Planning & Zoning Department

BOARD ACTION REPORT – APPEALABLE ITEM

Project Name: Resource Point of Sale (RPOS)
Project Location: 1044 SW 10th Avenue
Request: Class III Site Plan Modification
Board: Site Plan Review and Appearance Board (SPRAB)
Meeting Date: March 9, 2016

---STAFF REPORT---

ReSource POS
 Net Areas Plan Diagram for
 Special Action for Parking Reduction
 22 February 2016

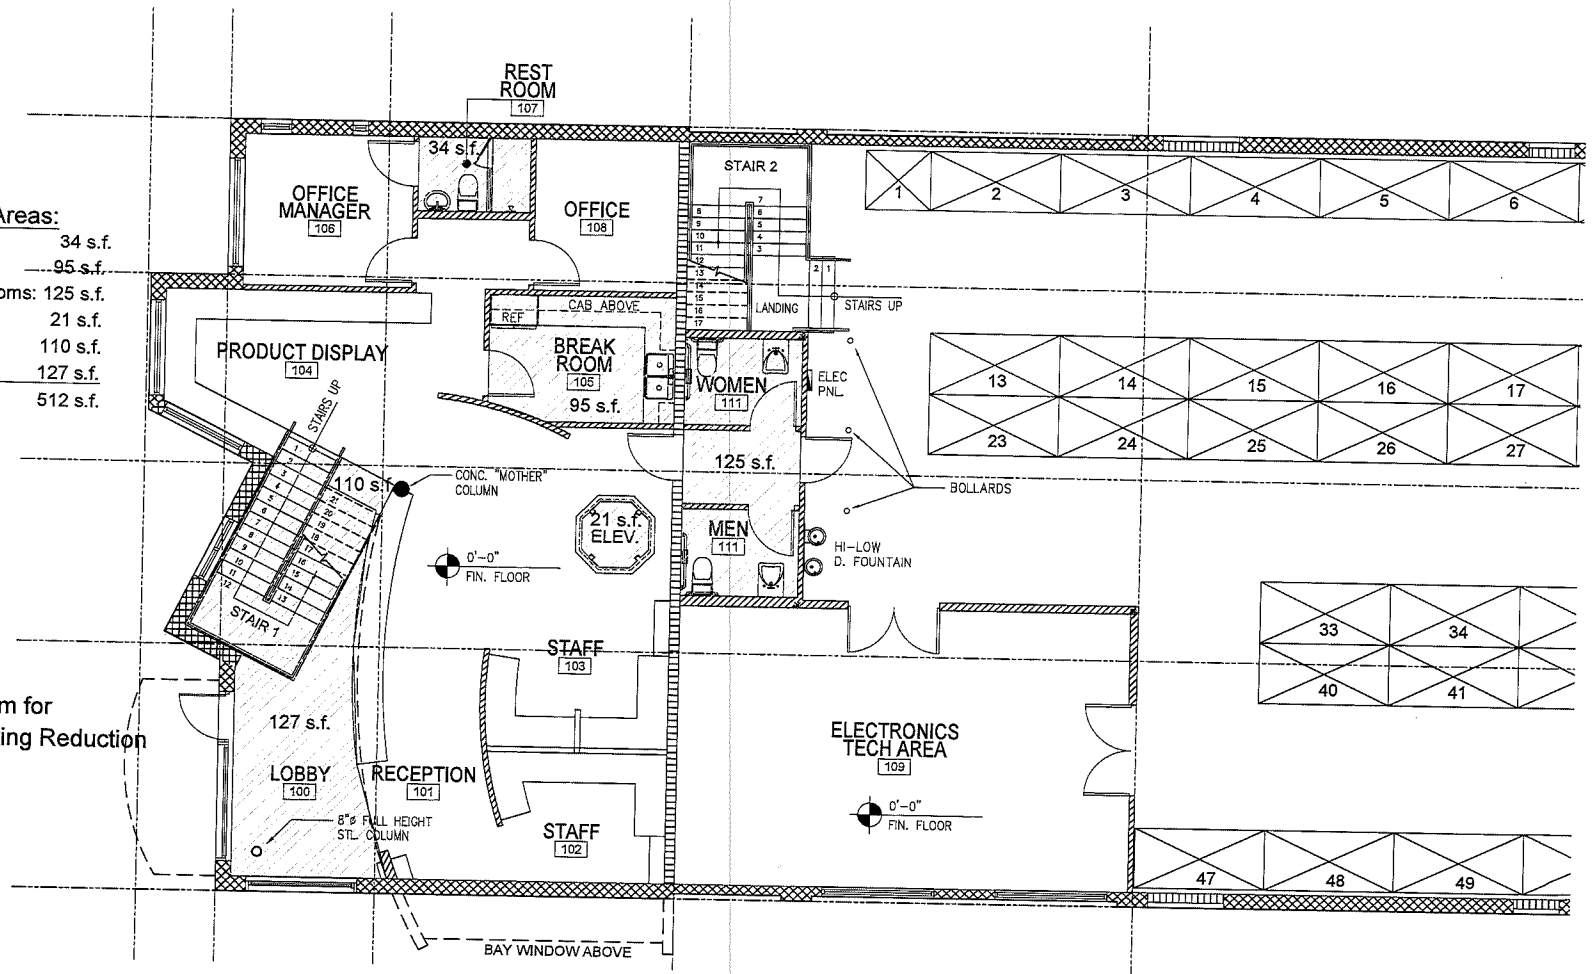
Move **approval** of the special action parking reduction request for Resource Point of Sale (RPOS) to provide 15 spaces whereas 17 is required, pursuant to LDR Section 4.6.9(F)(1), which allows for reduced parking when upon receipt and acceptance of special documentation it is conclusively demonstrated that a reduced number of parking spaces will accommodate a specific use, the body which acts on the attendant site plan may reduce the parking requirements accordingly.

A-1.0

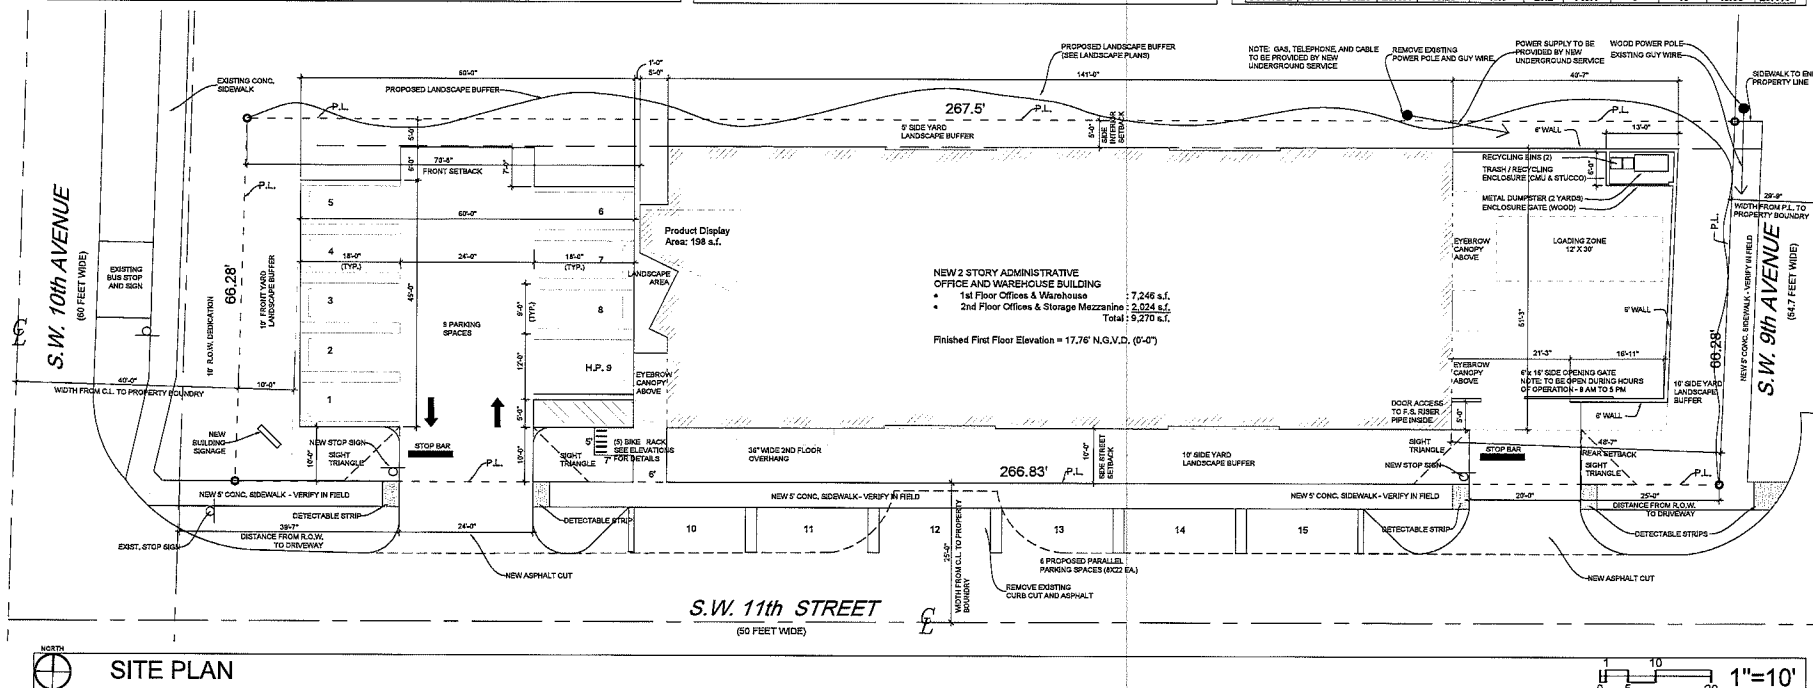
For the overall development consisting of 9,314 sq. ft., a total of 17 parking spaces is required and 15 parking spaces have been provided. Based on the above, this parking requirement is not met. Accordingly, plans will have to be revised to accommodate an additional 2 parking spaces unless the special action parking reduction request is approved, which is discussed later in the "Special Action Parking Reduction" section of this report.

1. To eliminate stacking concerns, the security gates shall only be utilized after hours, when the business is closed.
2. On the site plan (Sheet A-1.0), pursuant to LDR Section 4.6.9(D)(3)(c), dimension and label all stacking distances provided (i.e. security gates and driveway entrances). They are misrepresented.
3. Per LDR Section 2.4.3(B)(1), all plans (i.e. tree removal plan (1"=40'), pollution prevention plan (1"=30'), demolition plan (1"=20'), civil plans (1"=20'), etc.) shall be at the same engineering scale as the site plan (1"=10'). Redraw applicable plan sheets for consistency.

2. To eliminate stacking concerns, the security gates shall only be utilized after hours, when the business is closed.
3. On the site plan (Sheet A-1.0), pursuant to LDR Section 4.6.9(D)(3)(c), dimension and label all stacking distances provided (i.e. security gates and driveway entrances). They are misrepresented.

E1.1

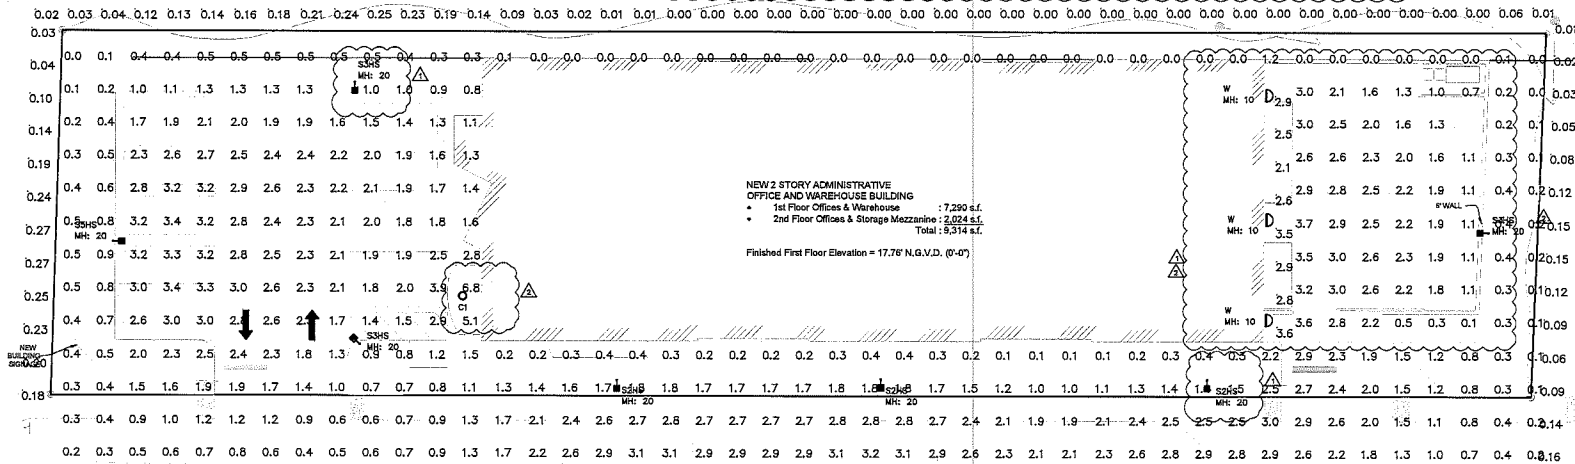
For buildings and structures, point calculations must be provided which meet the minimum and maximum requirements for accent pathways, building entrances, landscape lighting, canopies and overhangs. A photometric plan (Sheet E1.1) has been provided, which appears to meet these minimum and maximum standards. Thus, this LDR requirement is met.
